From: BRYAN Martin (EXT) [Martin.Bryan.ext@areva.com]
Sent: Wednesday, June 02, 2010 11:56 AM
To: Tesfaye, Getachew
Cc: DELANO Karen V (AREVA NP INC); ROMINE Judy (AREVA NP INC); BENNETT Kathy A (OFR) (AREVA NP INC); HAMMOND Philip R (AREVA NP INC)
Subject: Response to U.S. EPR Design Certification Application RAI No. 306, FSAR Ch. 3, Supplement 3
Attachments: RAI 306 Supplement 3 Response US EPR DC.pdf

Request for Additional Information No. 306, Supplement 3

U.S. EPR Standard Design Certification

**SRP Section: 03.12 - ASME Code Class 1, 2, and 3 Piping Systems and Piping
Components and Their Associated Supports**

Figure 03.12-20-1—Branch of SIS/RHRS/EBS Injection Lines – Trains 1 & 4

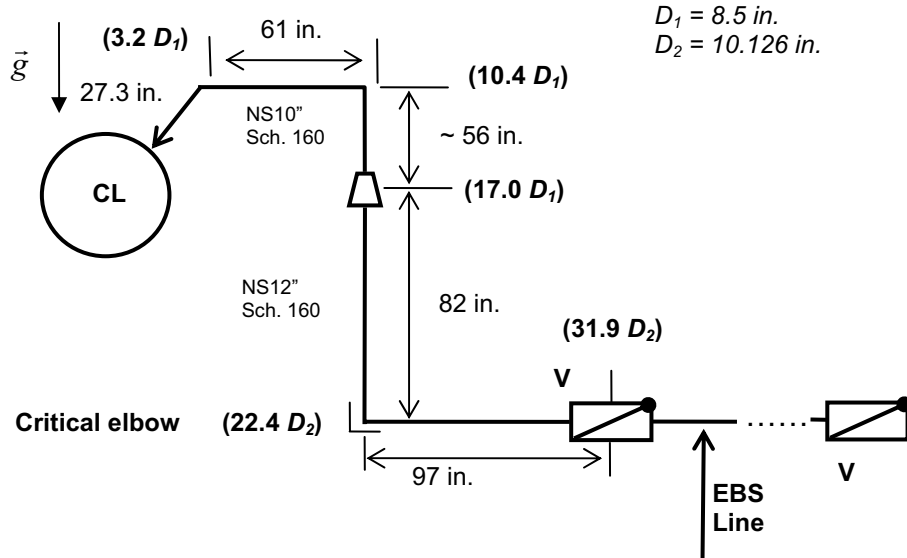
The staff noted that the cyclic thermal stratification occurring within such RCS attached piping is affected by the line orientation and geometry. The staff requests AREVA to provide detailed line geometry information (e.g. L/Di, DH/H/LH configuration) for each of the above mentioned lines in order to determine that the thermal stratification does not occur in any horizontal segment of the RCS attached piping.

1. RHR/SIS/EBS injection and RHR/SIS suction RCS attached piping are both located in a downward-horizontal (DH) configuration from the RCS. The requested detailed piping information for the RCS attached RHR/SIS/EBS injection lines of trains 1 to 4 is shown in Figure 03.12-20-1 and Figure 03.12-20-2, and the RCS attached SIS/RHR suction lines of trains 1 to 4 is shown in Figure 03.12-20-3 and Figure 03.12-20-4. The cumulative pipe lengths, with respect of the pipe inner diameter (Di), are indicated within parentheses.
